**ADDENDUM NO. 3
PROJECT BI-CTC-455**

Date: April 30, 2015
Renovations and Addition to Lafayette Hall
Housatonic Community College
Bridgeport, CT

ADDENDUM #3

Renovations and New Addition to Lafayette Hall
Housatonic Community College
Bridgeport, Connecticut

3 Bollard and Light Pole Foundations
 LP6.00 Not to Scale

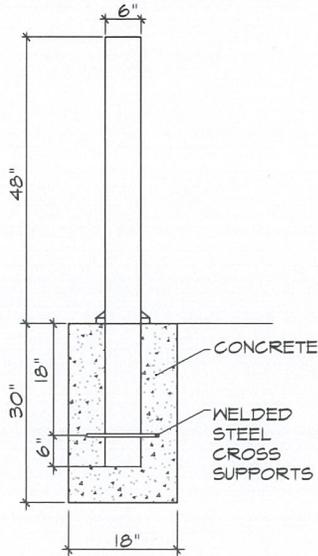
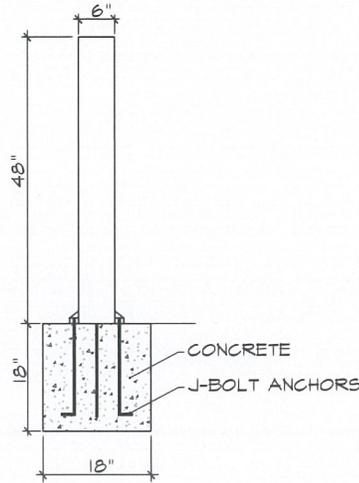
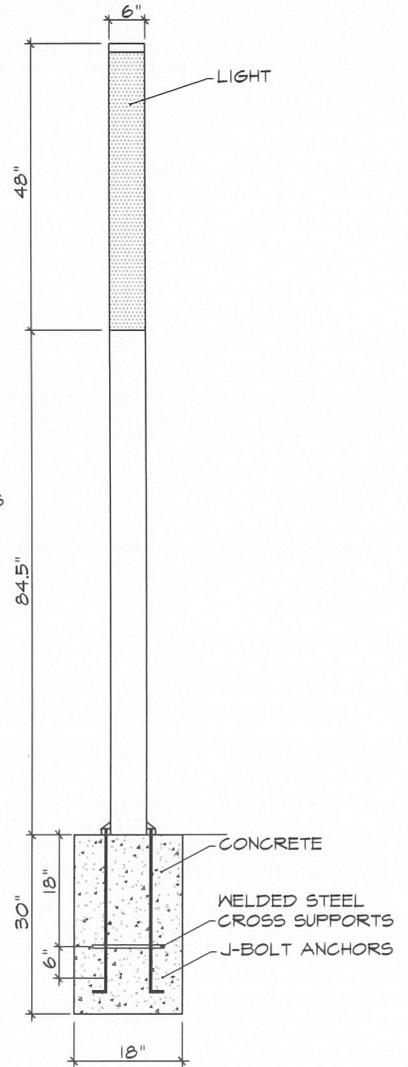
- Bollard and Light Pole Foundations: **ADD** note to clarify bollard type/product as indicated on sketch AD3-LP1.

Note:
 Bollard type BLS is specified within the lighting fixture schedule, type BL as indicated on Sheet E0.02. Bollard types BS and B as indicated on LP6.00 shall match the bollard indicated on E0.02 (manufacturer, material, etc.), without the electrical components.

2 **BRACED FRAME COLUMN SPLICE DETAIL**
S4.01 NOT TO SCALE

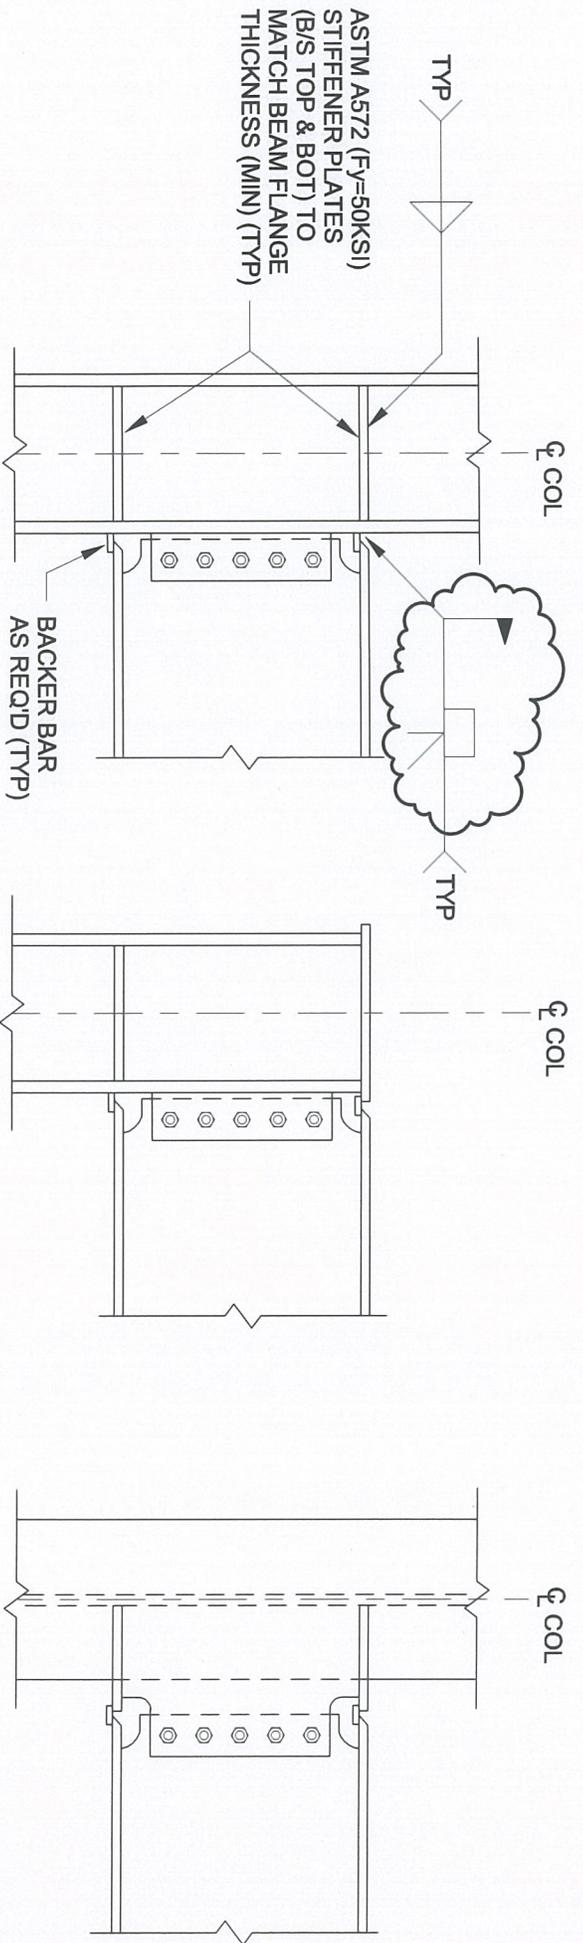
- Detail 2/S4.01: **MODIFY** weld designations as indicated on sketch AD3-S1.
- Detail 6/S4.01: **MODIFY** weld designations as indicated on sketch AD3-S2.
- Detail 8/S4.01: **MODIFY** weld designations as indicated on sketch AD3-S3.
- Detail 9/S4.01: **MODIFY** weld designations as indicated on sketch AD3-S4.

1. COLUMN SPLICE WELDED CONNECTION TO PROVIDE FULL MOMENT CAPACITY OF UPPER COLUMNS.
2. DEPTH OF D_u AND D_b NOMINALLY THE SAME.
3. PROVIDE ADDITIONAL STEEL AS REQUIRED TO STABILIZE COLUMN DURING ERECTION. REMOVE AS REQUIRED FOR ARCHITECTURAL FINISH.
